ADDENDUM NO. 1

February 5, 2019

This Addendum supplements and amends the original Plans and Specifications and shall be taken into account in preparing proposals and shall become a part of the contract documents.

**MUSOM
BOILER AND CHILLER
REPLACEMENT**

SCENARIO'S LISTED INDICATED EQUIPMENT IN OPERATION VALUES AT NON-OPERATING PUMP TO BE CLOSED IN CROSS CONNECTING SCENARIO.

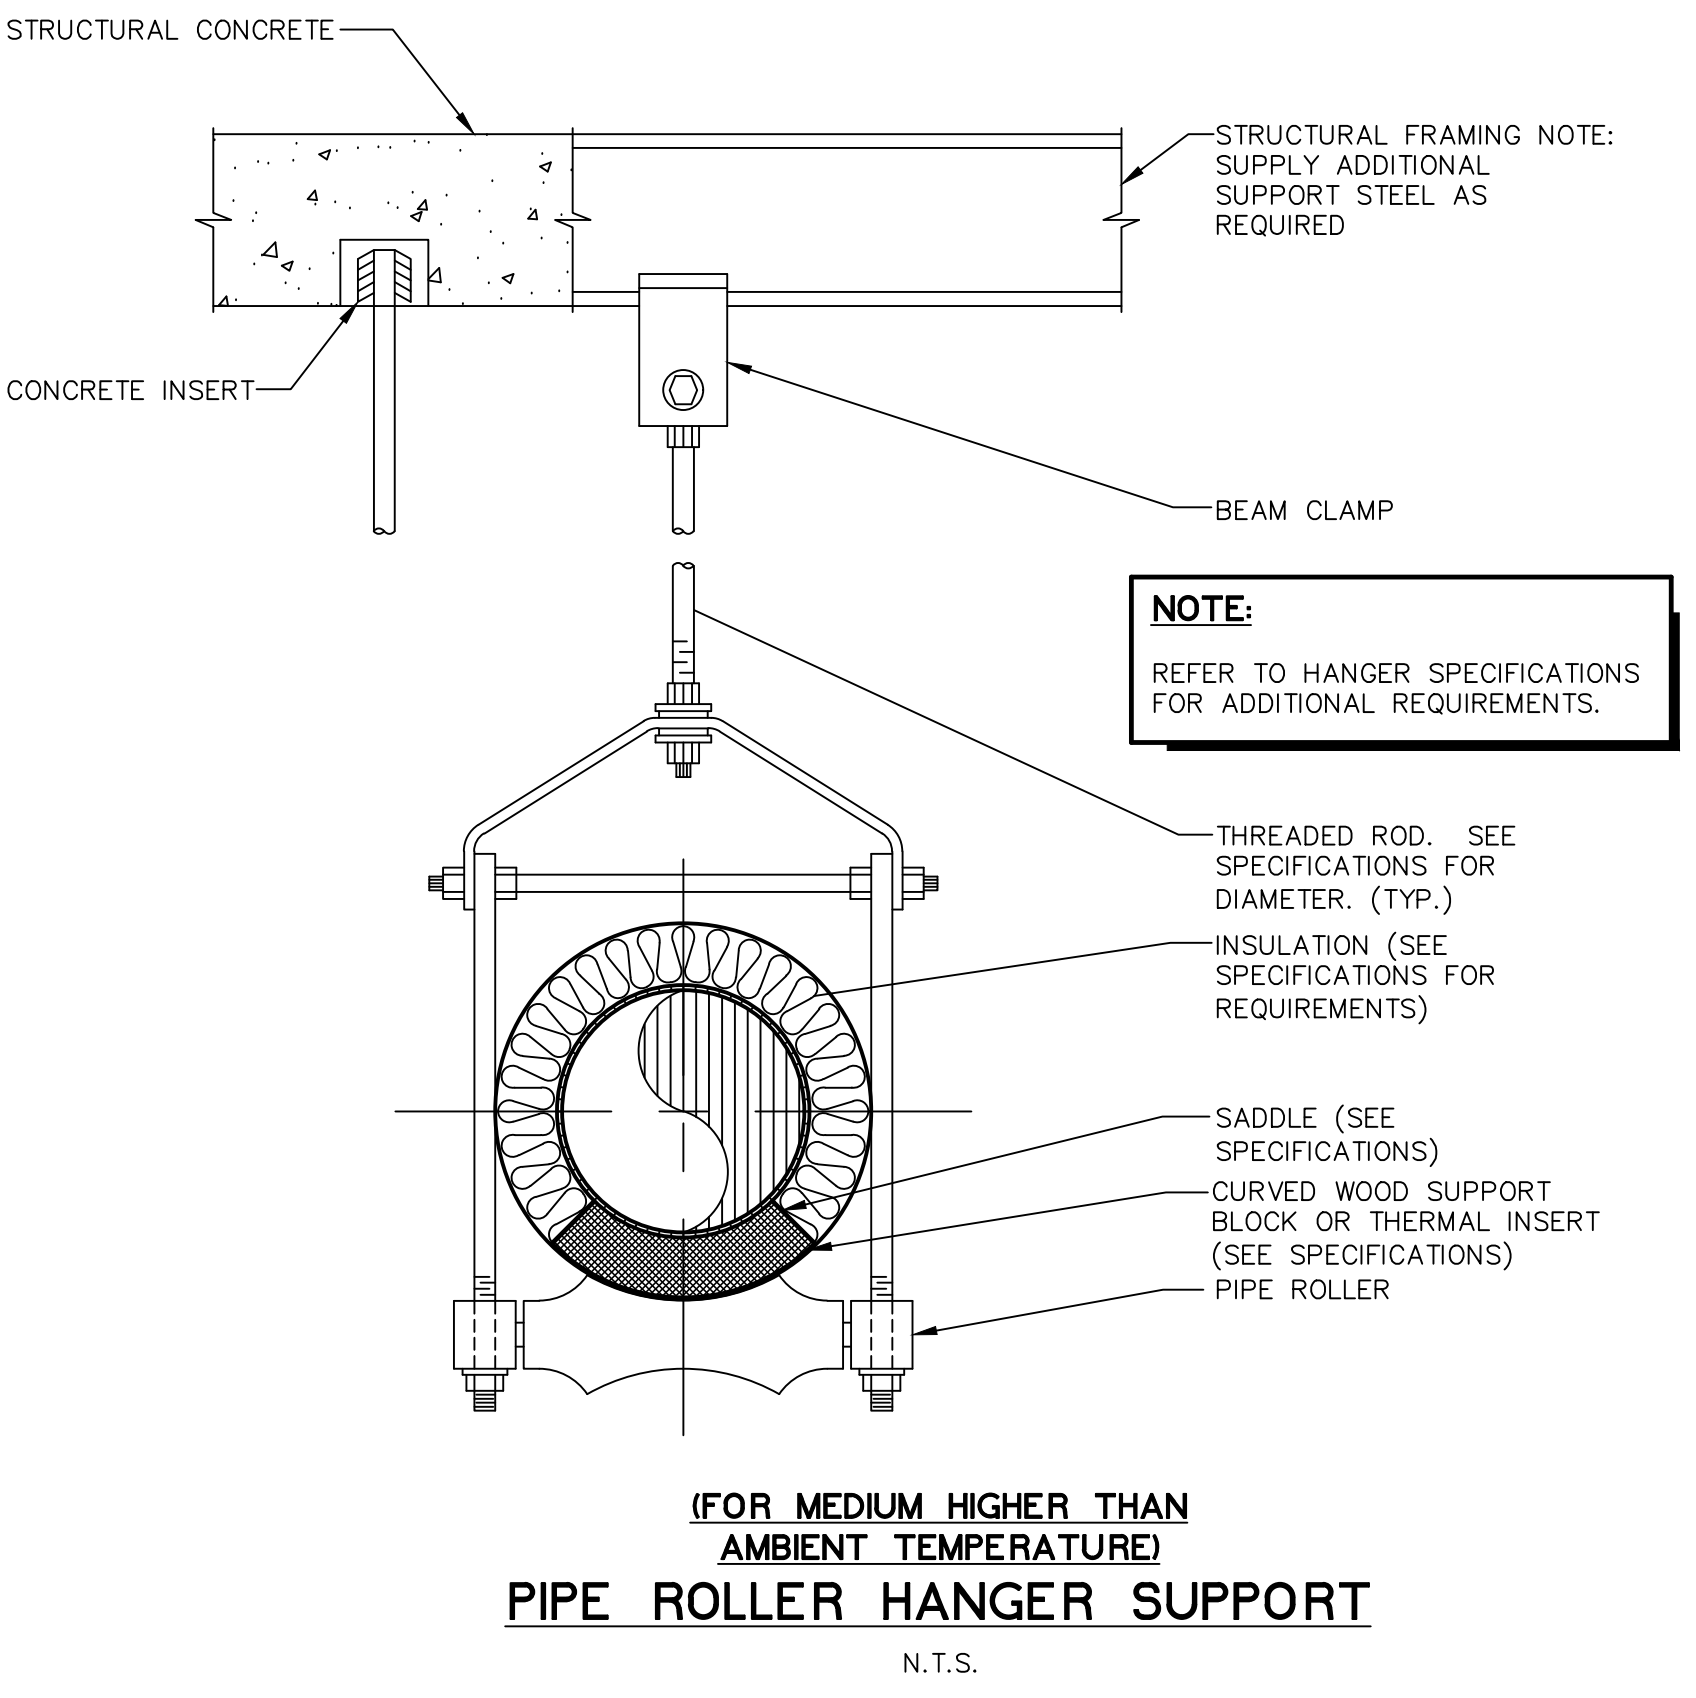
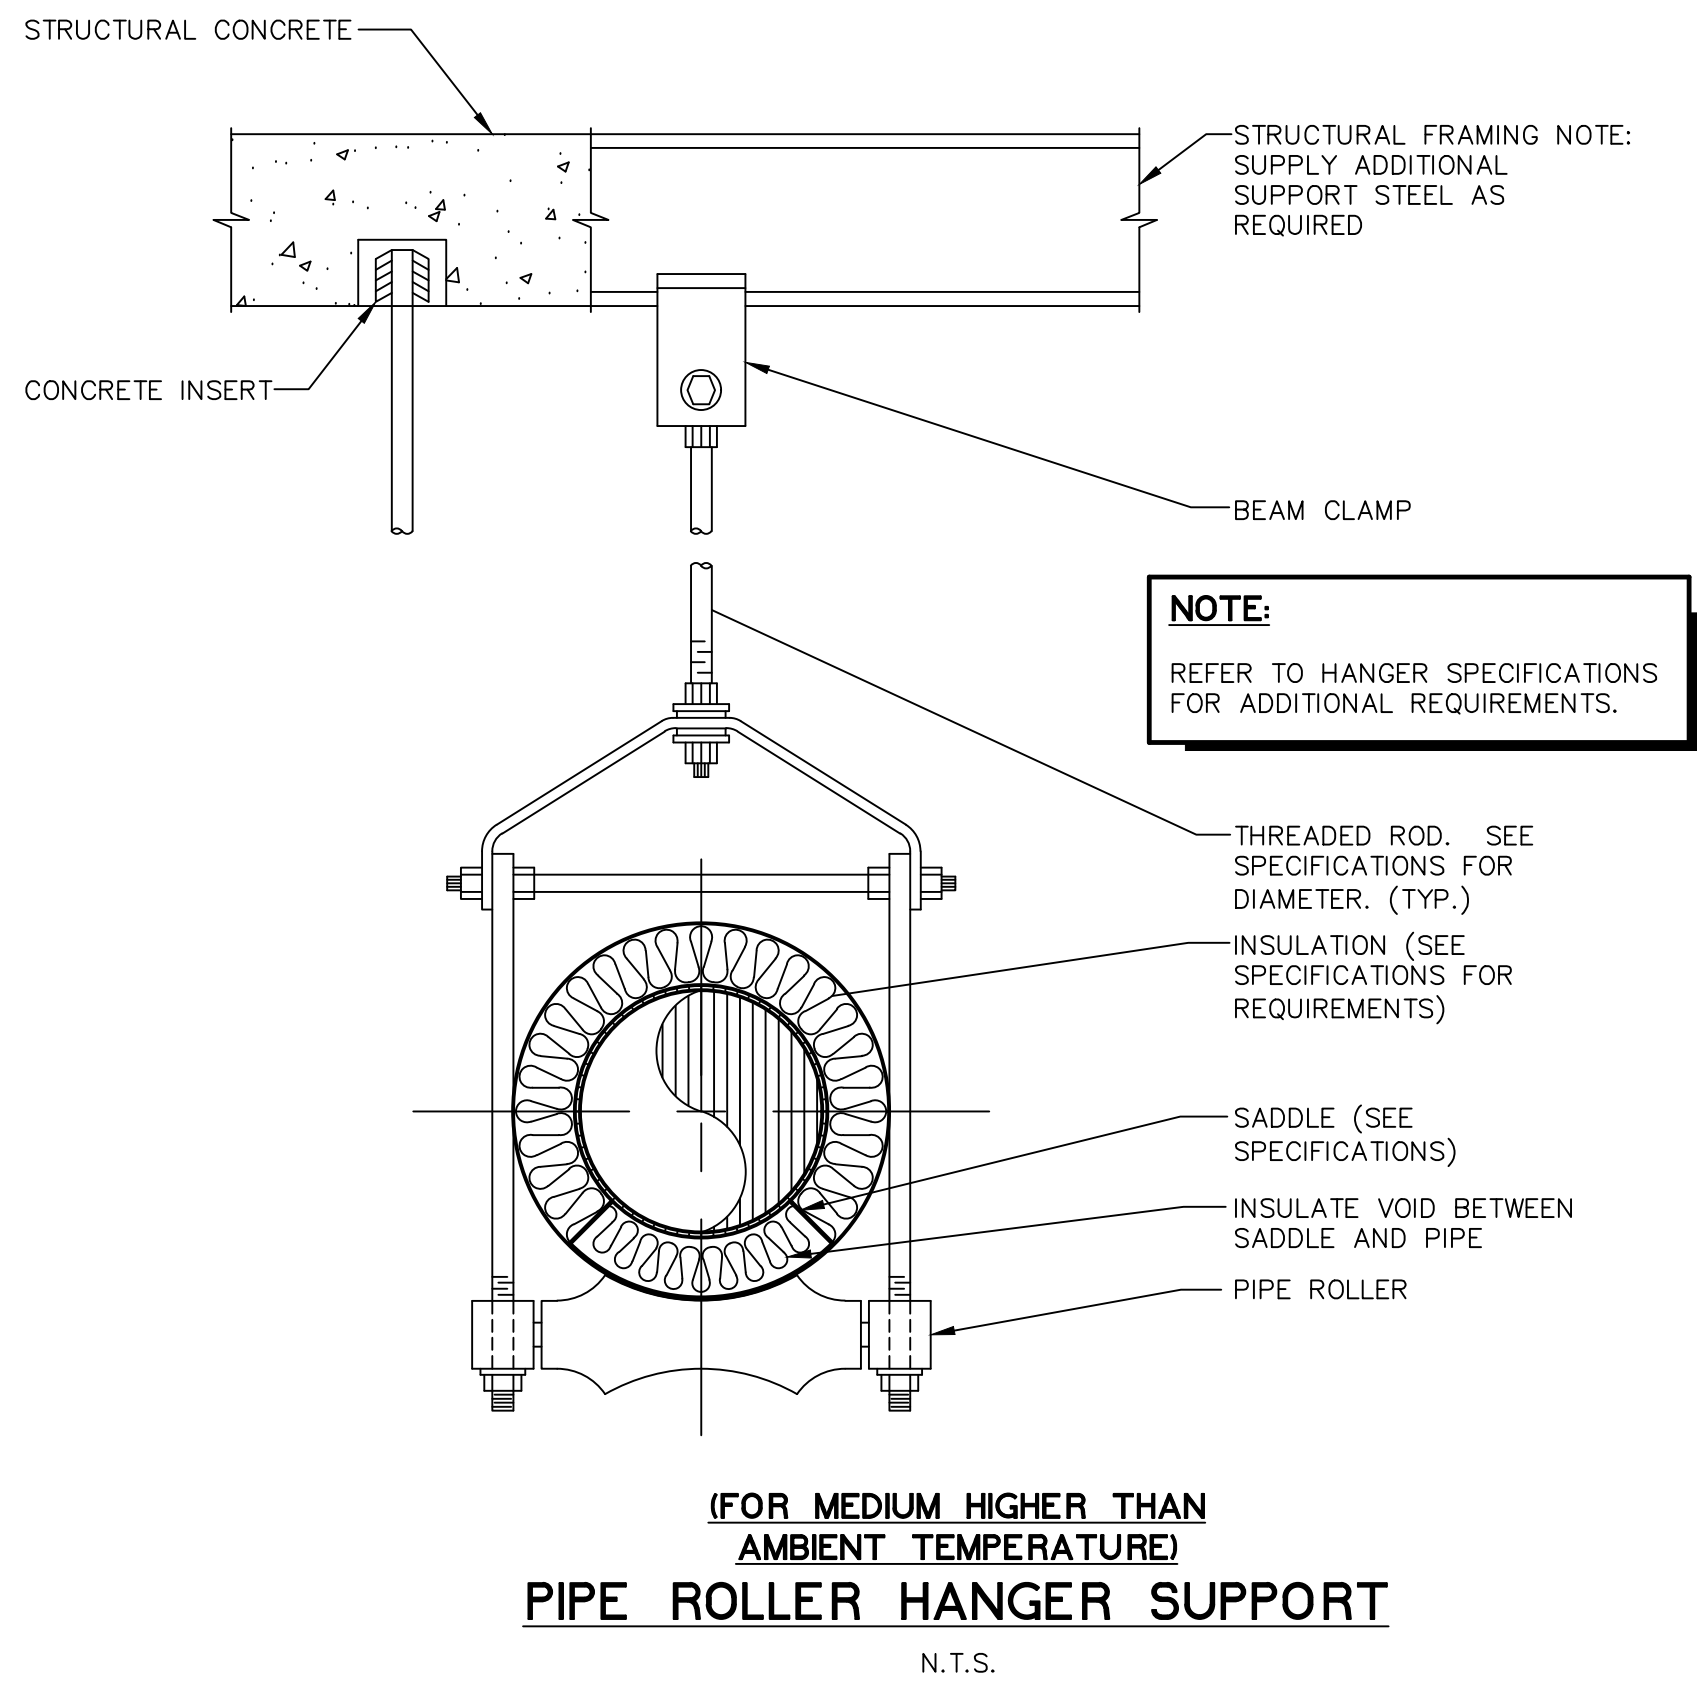
- These pads are to be removed.
- ITEM 10 Sheet M1, "General Notes, Symbol Legend, Details and Schedules"
- Refer to attached sheet M1 for removal of "In-Line Pump Installation Detail".

- Refer to attached sheet M1 for addition of "End Suction Water Pump Isometric".
 - Refer to attached sheet M1 for removal of "Hydronic Pump Schedule".

- Refer to attached sheet M1 for removal of "Buffer Tank Schedule".
- ITEM 11 Sheet MD1, "Demolition – Floor Plan – HVAC (Piping)";
- Refer to attached sheet MD1 for modifications to removal of heating water piping.

M3

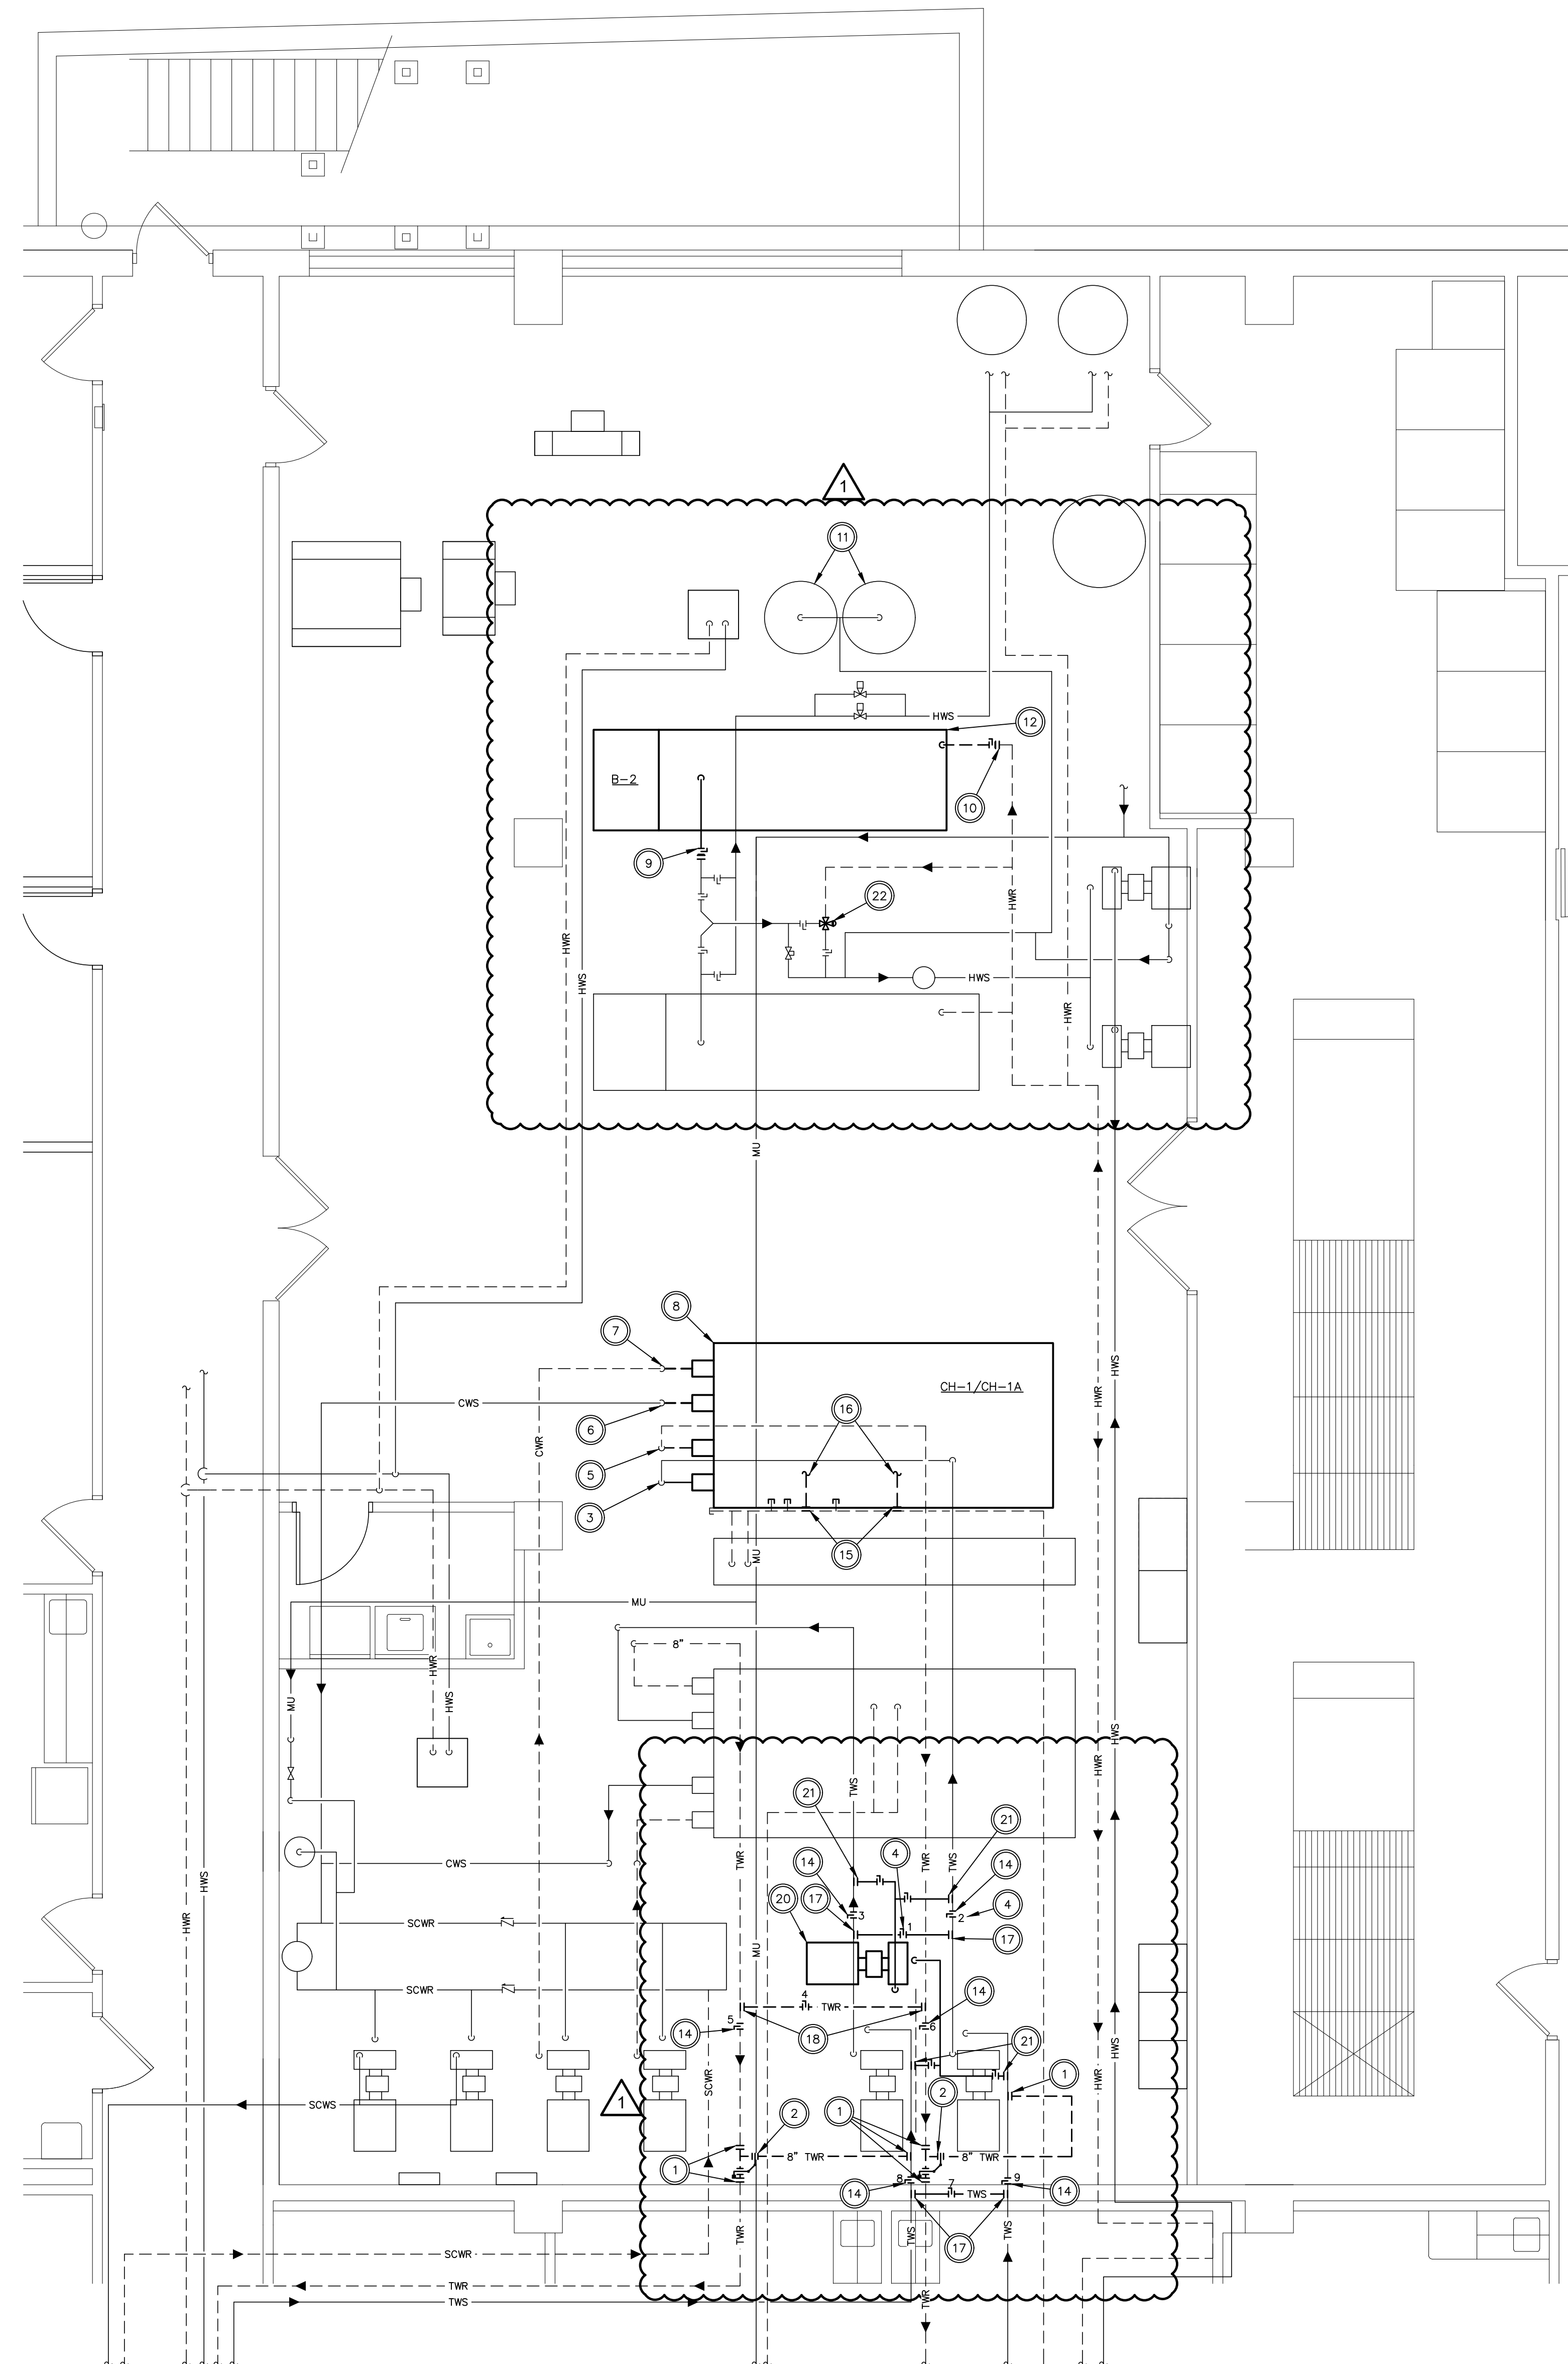
- Refer to attached sheet MD1 for removal of storage tank along chiller being removed.
- ITEM 12 Sheet M3, "New Work – Floor Plan – HVAC (Piping)";
- Refer to attached sheet M3 for modifications to heating water piping and equipment.

- Refer to attached sheet M3 for addition of tower water pump, CP-3 and associated tower water piping.
 - Refer to attached sheet M3 for modification of tower water bypass.

- Refer to attached sheet M3 for tower water cross connect piping to be installed under add alternate.
- ITEM 13 Sheet M4 "Demo/New Work – Flow Diagrams & Temperature Controls";
